I-85 SEWER EXTENSION  
CONTRACT 1B – COLLECTIONS

ADDENDUM NO. 6

January 10, 2024

Gaffney Board of Public Works  
I-85 Sewer Extension  
Contract 1B- Collections Broad River  
WWTP to Bear Den SPS

**HWY 329 BRIDGE PIPE SUPPORT DETAILS**

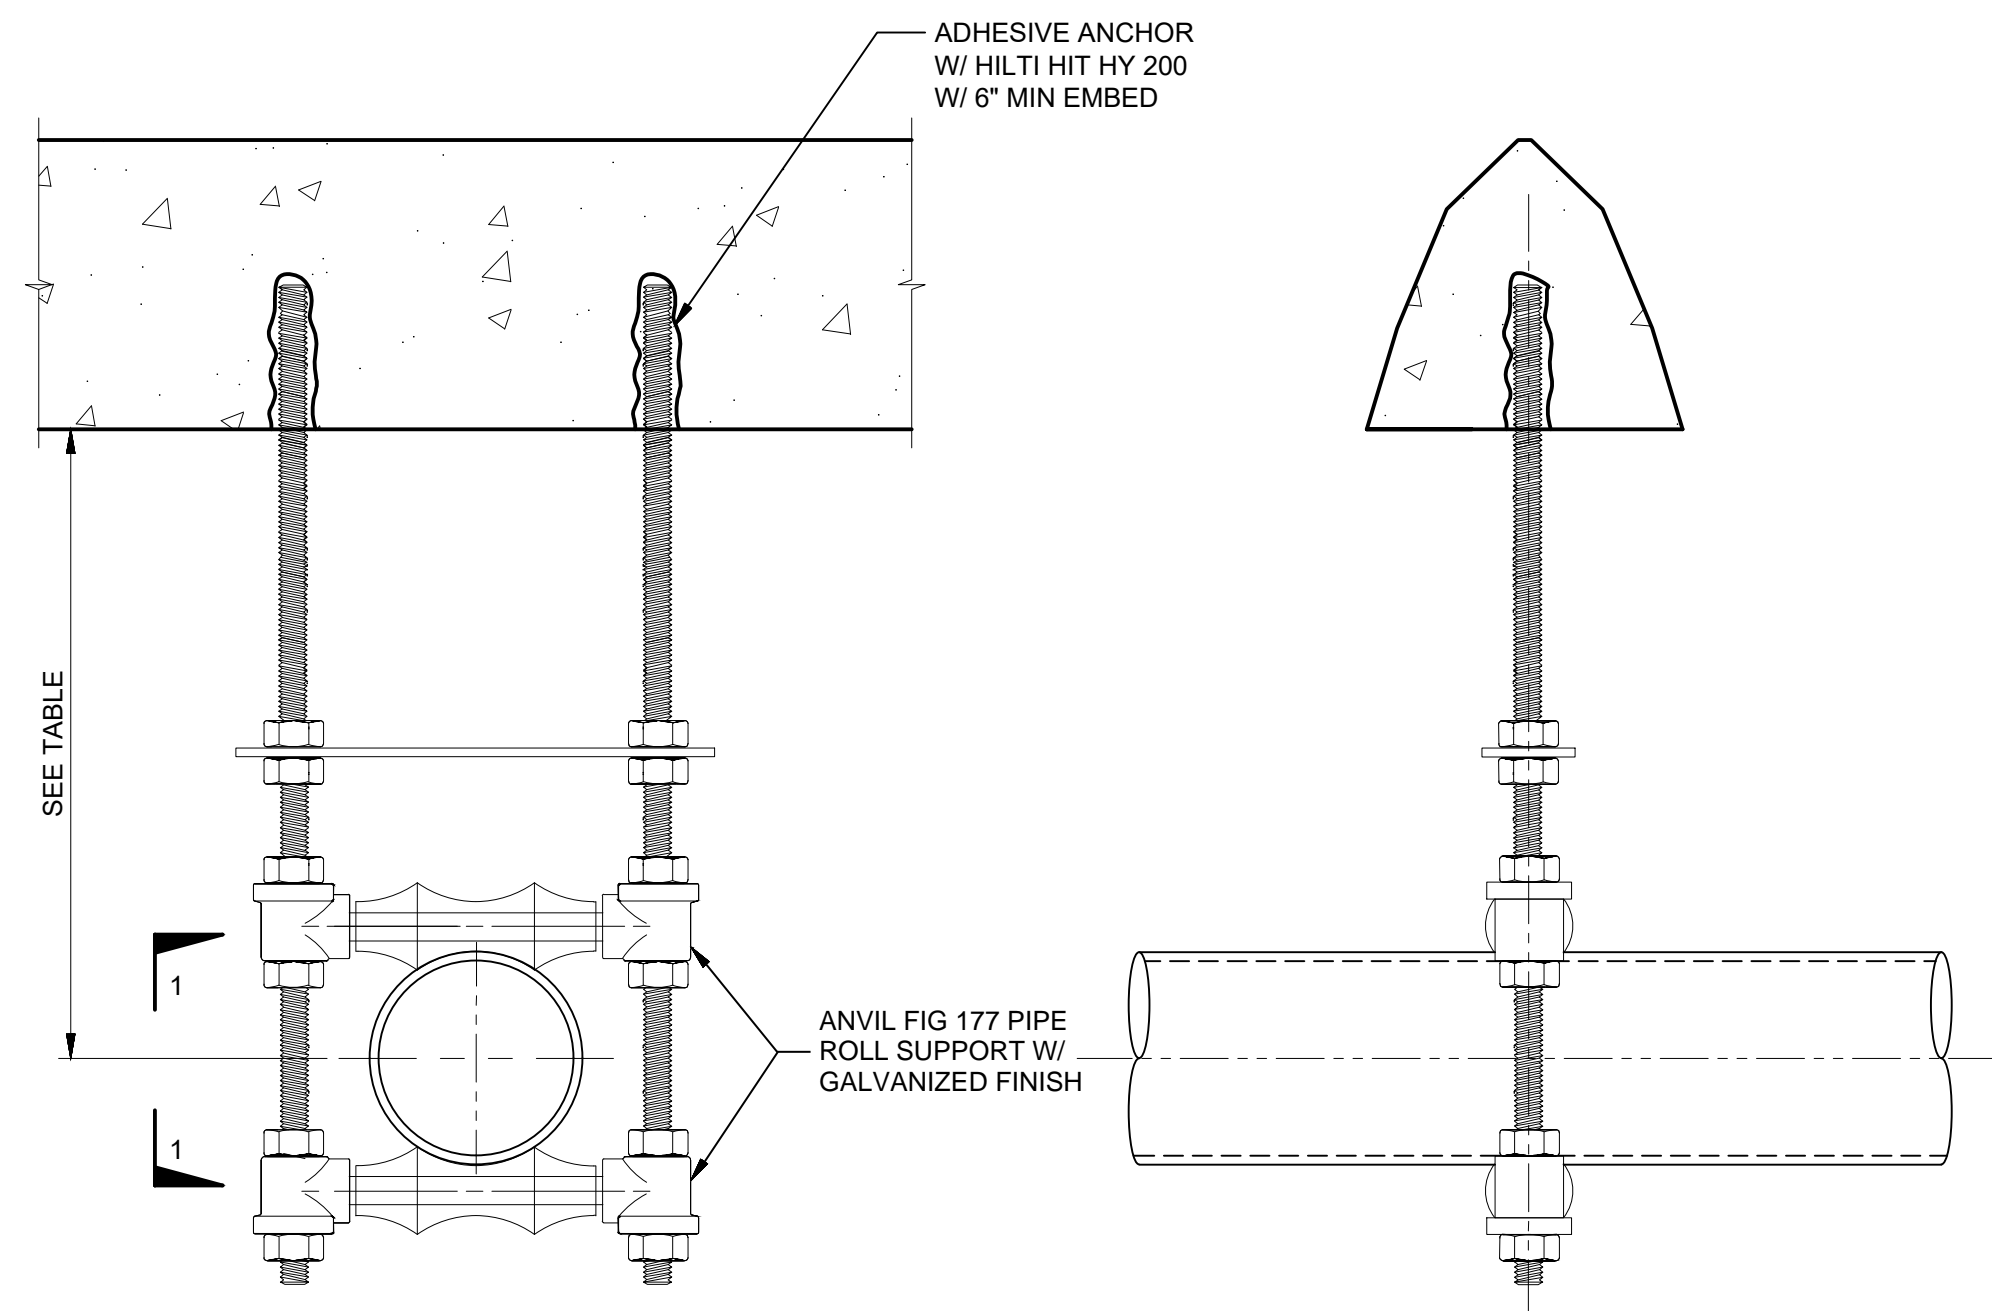
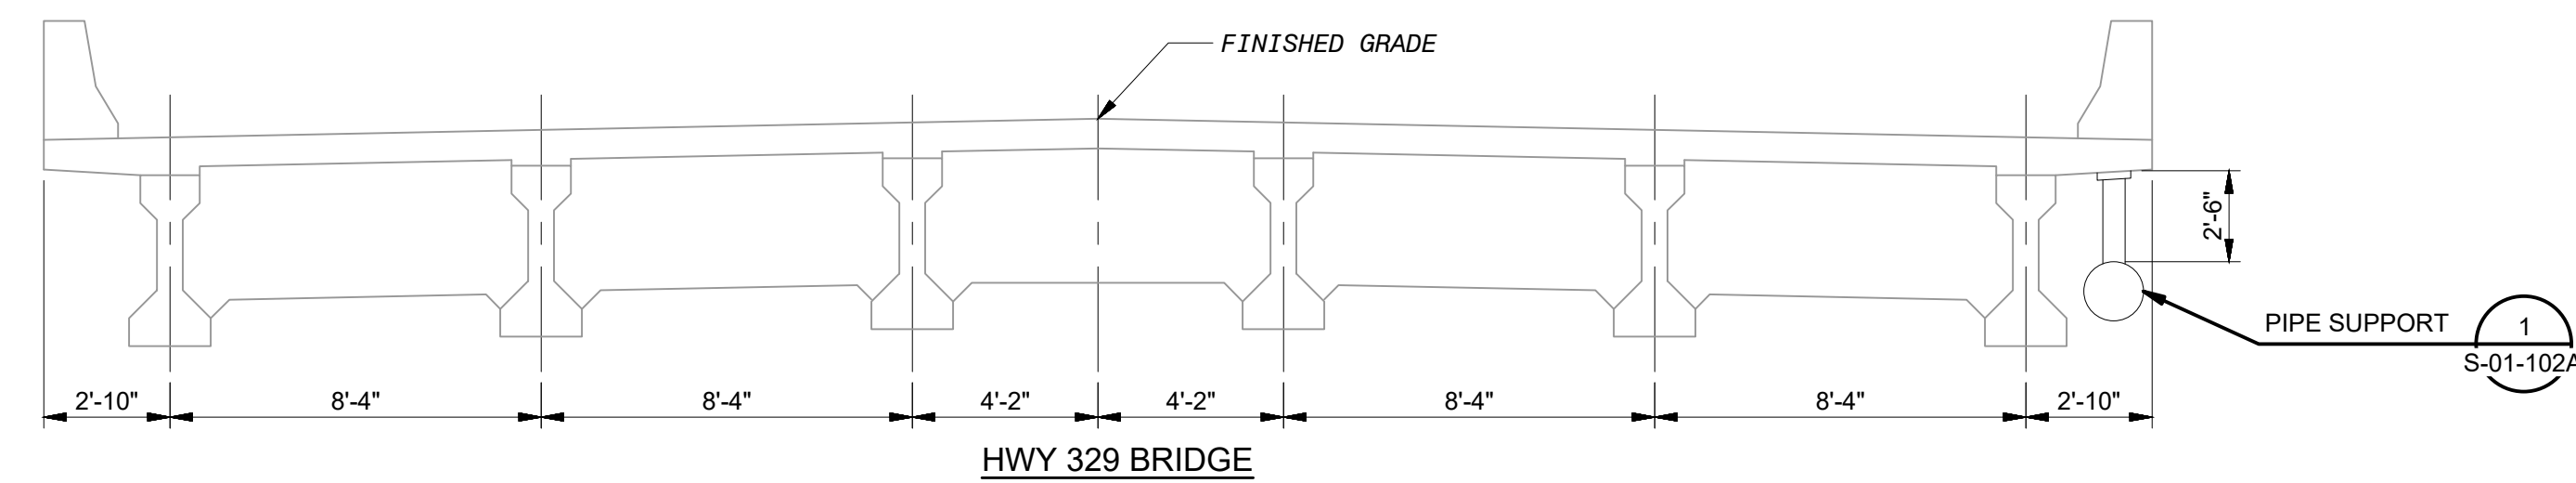
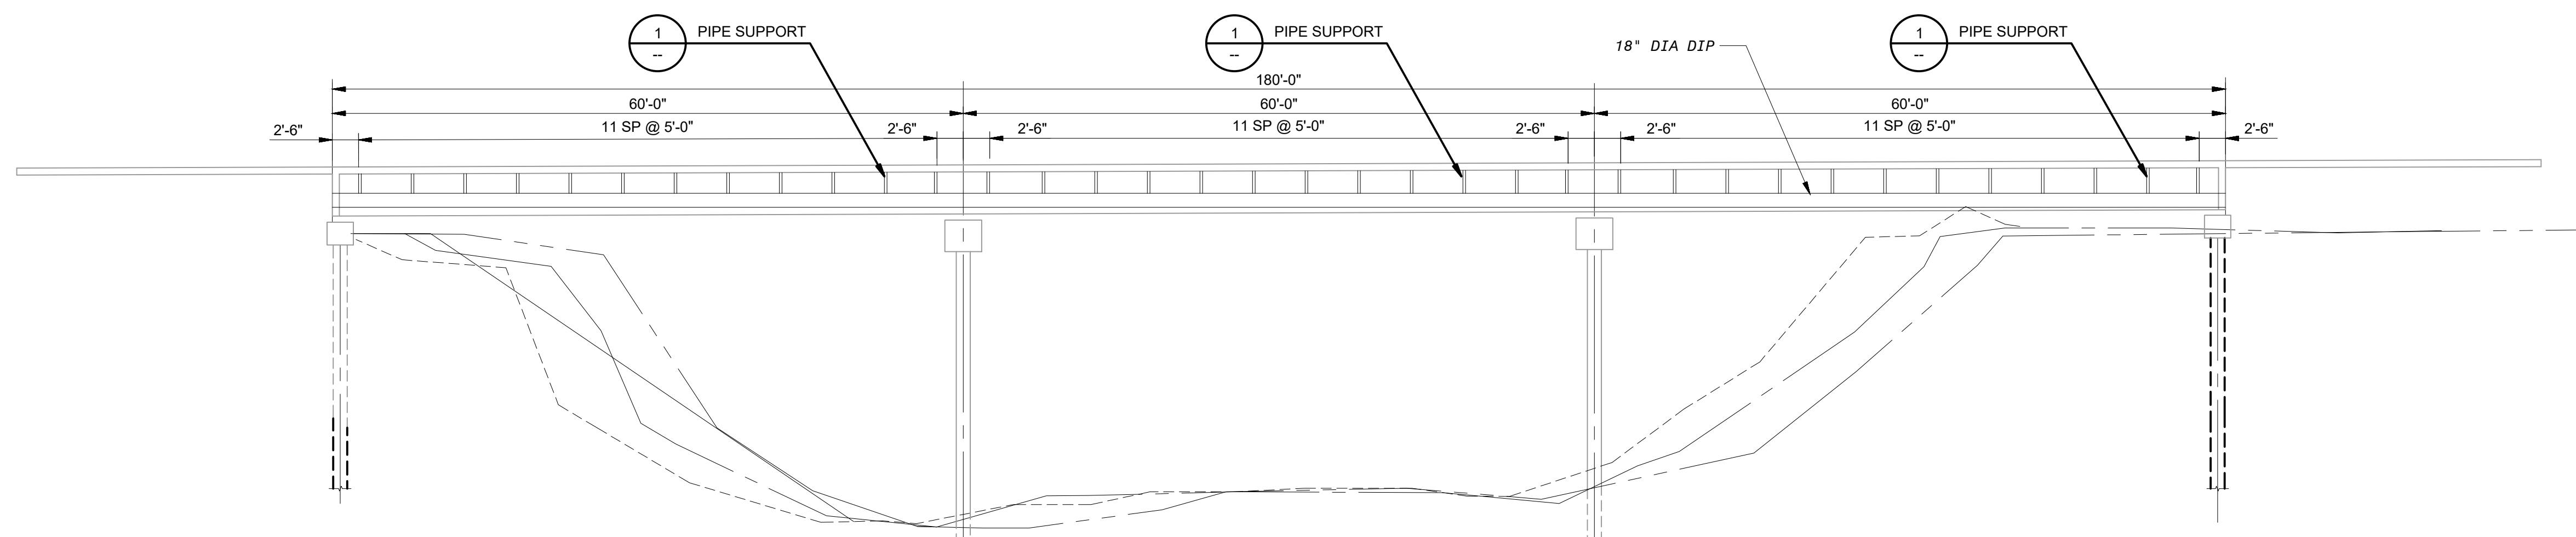
56	S-00-001	STANDARD STRUCTURAL NOTES
57	S-01-101A	HWY 329 BRIDGE PIPE SUPPORT DETAILS
58	S-01-102A	BLACKSBURG HWY BRIDGE PIPE SUPPORT DETAILS

- i. Insert the attached new sheets C-02-111A and C-02-112A for Segment 2 Alternative 1 and the new sheets C-03-114A and C-03-115A for Segment 3 Alternative 2 after sheet C-03-120.
- ii. Insert the attached new sheets S-00-001, S-01-101A, and S-01-102A for the Alternatives after sheet C-99-006.
